## #2018-04 Seven Eleven Gas Station – Special Use Permit Project Review for Planning and Zoning Commission

1. Special Use Permit to allow a Gasoline Service Station and Convenience Store with a Gasoline Electronic Pricing signs.
2. Variations from:
  - a) Article 2-400(C)(13) to allow a gas station canopy without a pitch,
  - b) Article 3-200 to allow a 10-foot rear yard setback, a variation of 10 feet,
  - c) Article 3-200 to allow 83.59% impervious surface coverage, a variation of 18.59%, and
  - d) Article 4-1000 to allow 410 square feet of wall signage.

11 Northwest Highway

Proposed North Elevation - Signs A, B, C & D

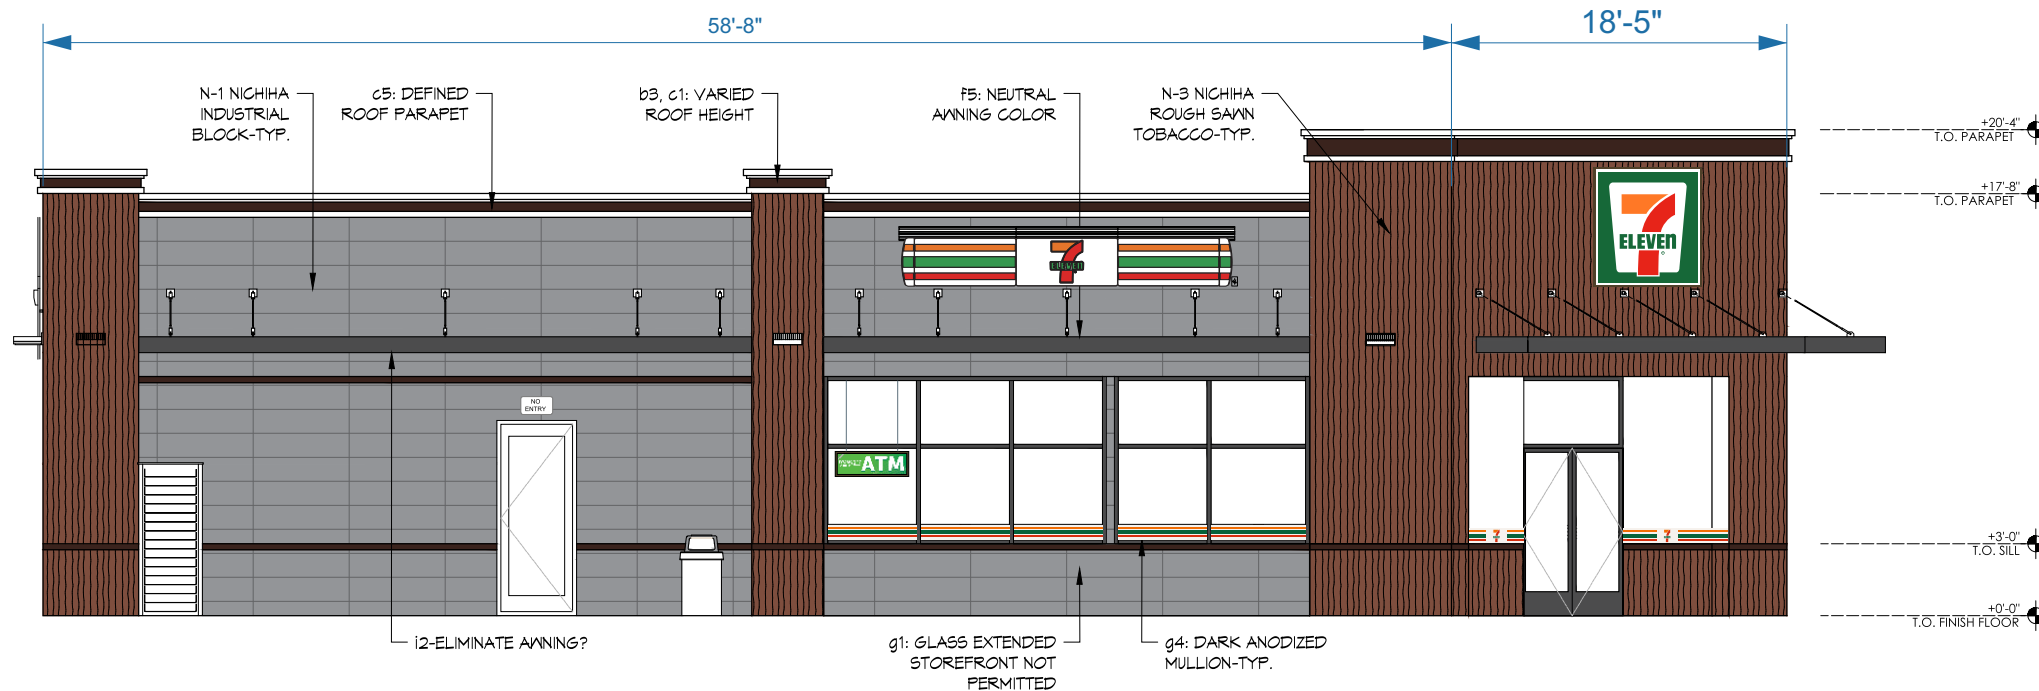
Proposed Sign	Size (square feet)	Recommended signage to be consistent with other recent approvals.
Wall sign over entry	25	Recommended.
North wall sign	27.5	Recommended.
West wall sign	27.5	Recommended.
Canopy (3 branding areas at corners)	16.6 x 3 = 49.8	Recommended.
Synergy Vertical Valance (6)	24.3 x 6 = 145.8 Without poster areas: 3.68 x 6 = 22.08	Not consistent with recent approvals, recommended removal of poster areas.
Synergy Horizontal Valance (6)	8.15 x 6 = 48.9	Recommended, these have been permitted through recent approvals.
Instructional Panel/Posters (12)	7.19 x 12 = 86.28	Not consistent with recent approvals, recommended removal.
Total	410.78	Recommended total 200.78

THREE (3): VERTICAL VALANCE (BREAKING WAVES)

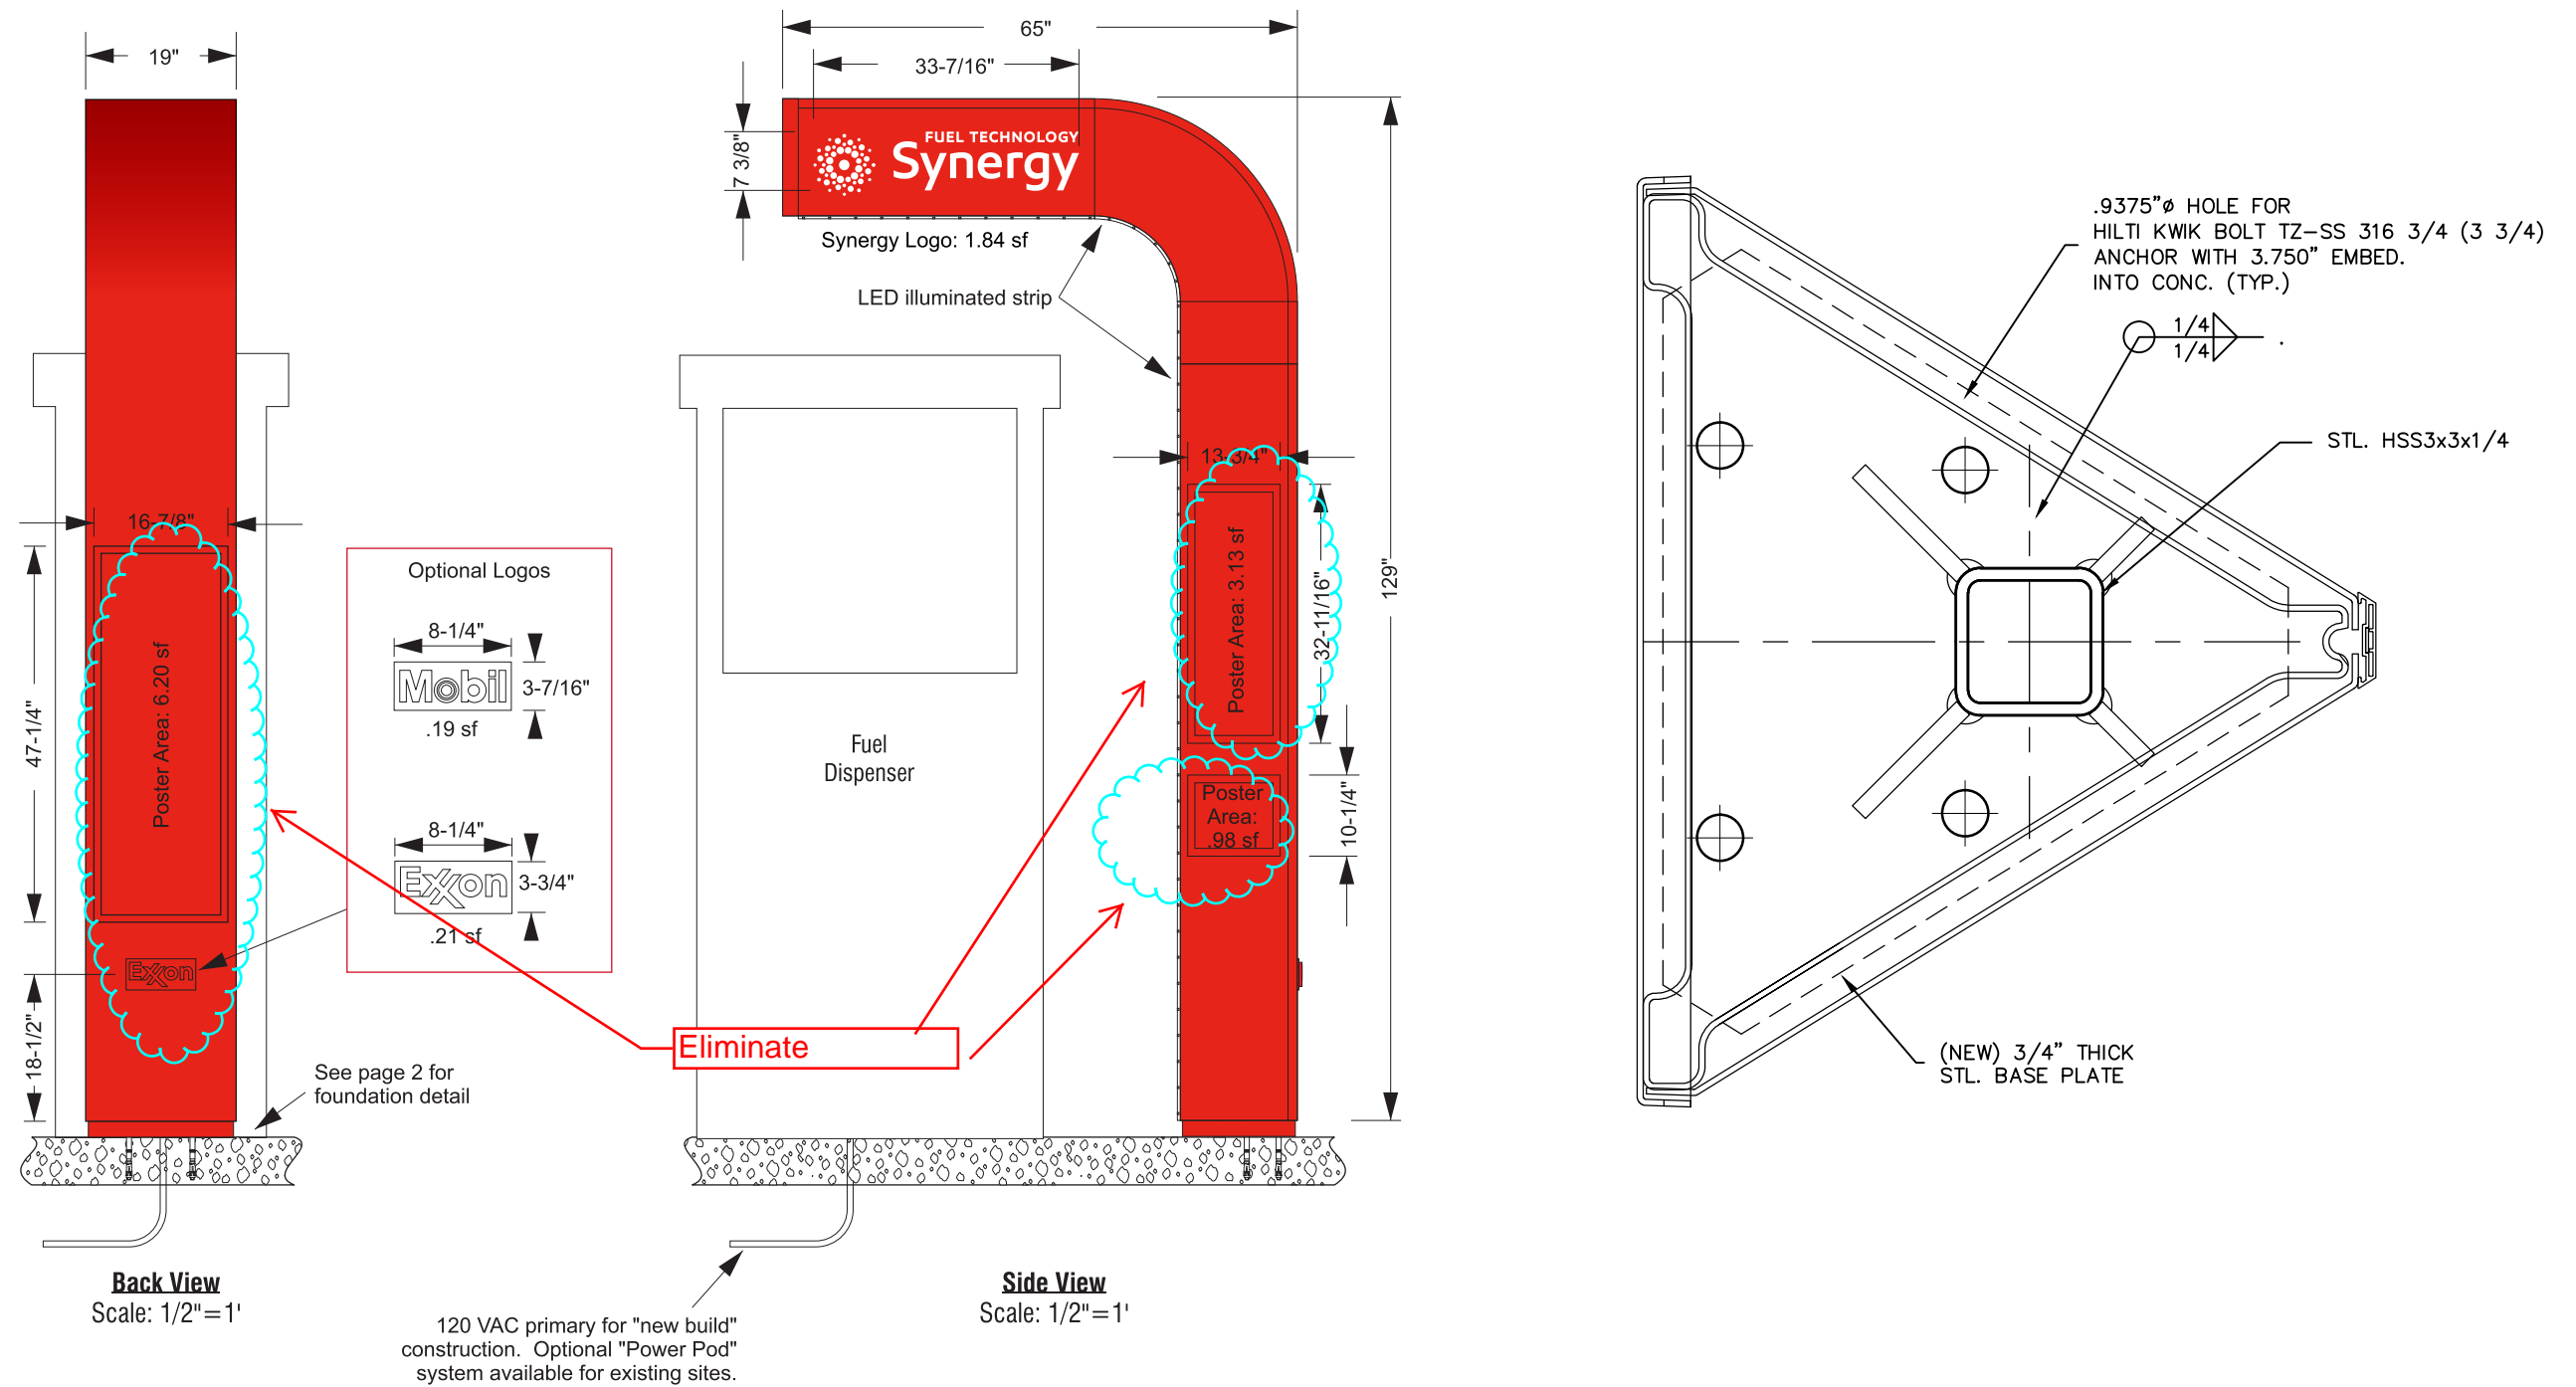
- B. Adjust gas vendor sign area illustrated on page A-3, Canopy Elevation to 16.6 square feet.
  - C. A variation to allow 200.78 square feet of wall signage, which includes the three building signs, three canopy signs, Synergy horizontal valance and Synergy vertical valance without poster sleeves signs is approved.

- D. All poster sleeves on the vertical valances (waves) and all instructional panels (koala) signs shall be eliminated from the sign package.
  - E. Poster signage is not allowed to be located on the gas canopy columns.

Face & Side Detail - Pump ID & Instructions Panels - RE-B 3 & 4

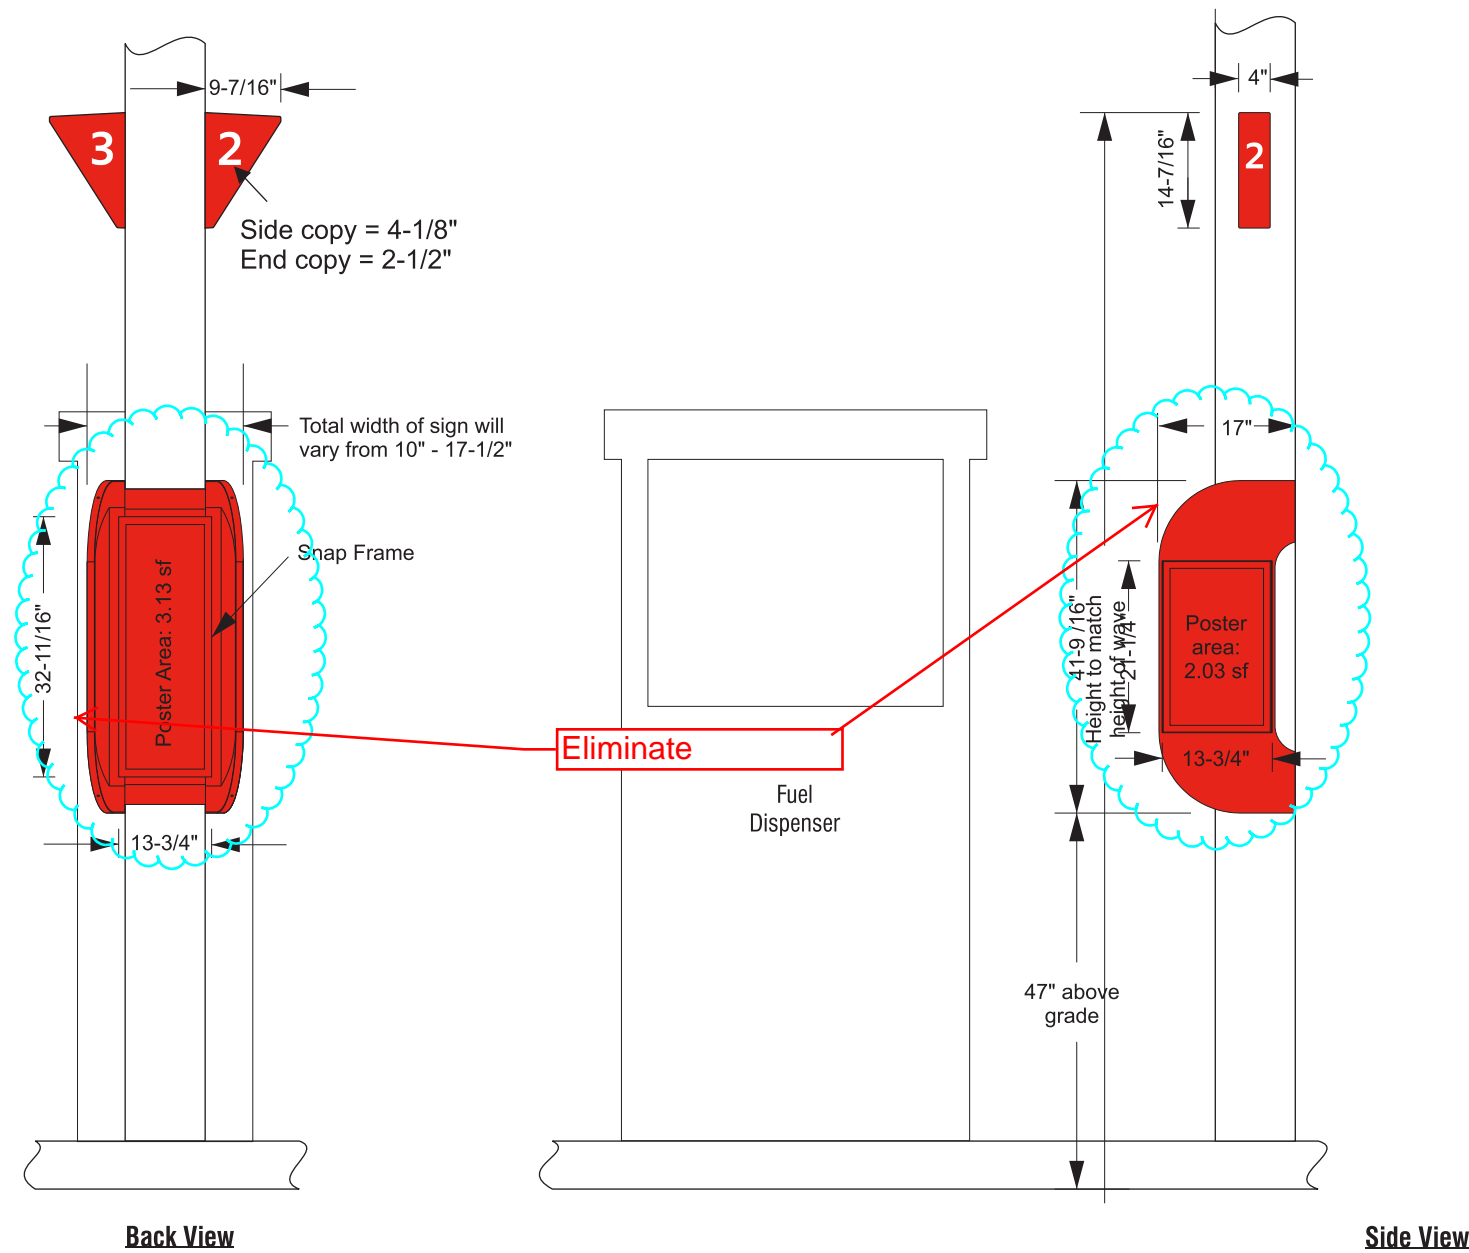
- The Instructional Panel/Posters have been requested to be removed from all other gas stations asking for this rebranding. A condition of approval requires that the poster advertising be eliminated from all vertical valances.
- The Pump ID and End caps have not been considered signage and do not count towards the total allowable wall signage.
- Casey's Gas Station was granted 252.05 square feet of wall signage and Bucky's was granted 209 square feet of wall signage. Both of these gas stations had a condition that prohibited any poster signs on any of the posts.
